AGENDA - IHAP

Meeting:	Georges River Independent Hearing Assessment Panel (IHAP)
Date:	Thursday, 23 February 2017
Time:	4pm
Venue:	Council Chambers, Civic Centre, Kogarah
Participants:	Adam Seton (Chairperson) Paul Vergotis (Panel Member) Juliet Grant (Panel Member) Cameron Jones (Community Representative)
Additional Invitees:	Meryl Bishop (Director – Environment and Planning) Tina Christy (Manager – Development and building) Cathy Mercer (Admin Assistant) Monica Wernej (Admin Assistant)

**REPORT TO GEORGES RIVER COUNCIL
IHAP MEETING OF THURSDAY, 23 FEBRUARY 2017**

IHAP Report No	3.1	Application No	DA2016/0314
Site Address & Ward Locality	25 Old Forest Road Lugarno Peakhurst Ward		
Proposal	Demolition of existing structures and construction of a two storey child care centre for 45 children		
Report Author/s	Senior Development Assessment Officer, Paula Bizimis		
Owners	Oxford Number 1 Pty Ltd		
Applicant	Mr George Antoniou		
Zoning	Zone R2 - Low Density Residential		
Date Of Lodgement	18/11/2016		
Submissions	16 submissions including a petition with 131 signatures objecting to the development		
Cost of Works	\$675,000.00		
Reason for Referral to IHAP	Non-compliance with Hurstvill

Fig.3 – rear elevation and section

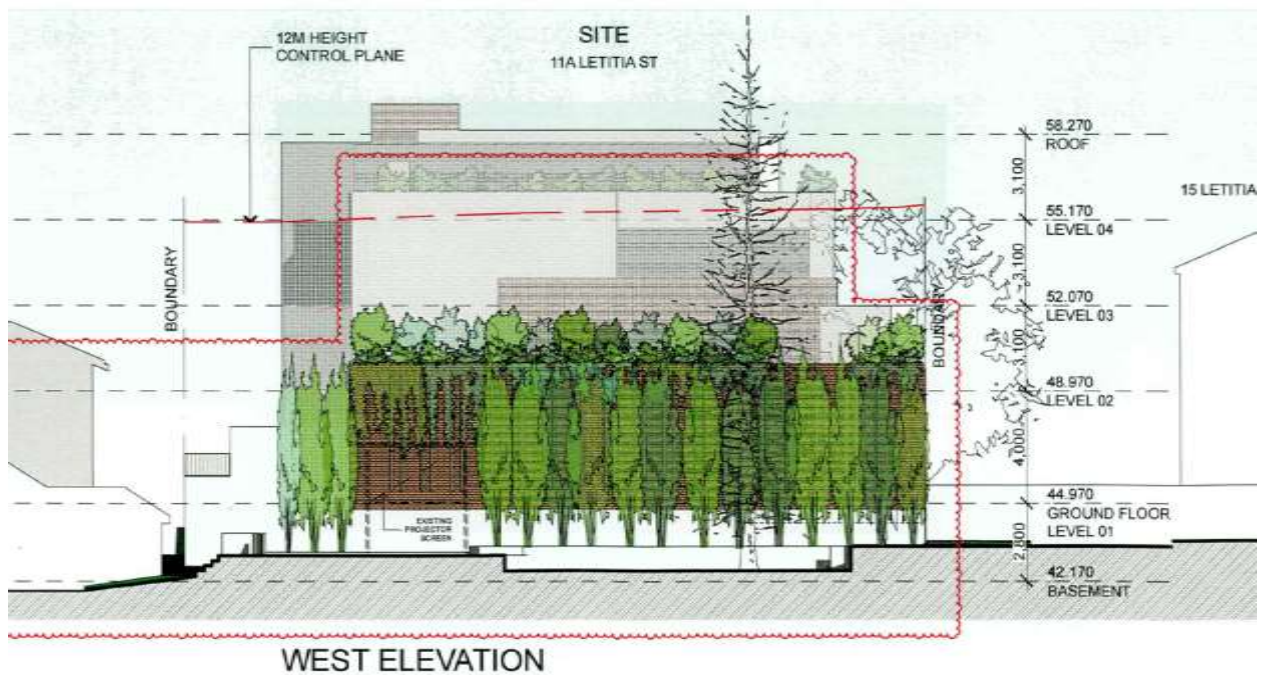
80. To the southern boundary, the proposal is setback as follows:

- Basement Level - 0m
- Ground floor (L1) – 0m to colonnade and 3.2m to the building wall.
- Level 2 – 3m
- Level 3 – 3 -3.2m
- Level 4 – 5.9m (excluding 800mm Juliet balcony protrusions)

81. The proposal results in what is effectively a four (4) storey wall on the boundary, with a setback upper level. In addition to the height non-compliance, the non-compliance with side and rear setbacks result in significant building mass being apportioned to the rear of the site. The proposal is not supported.
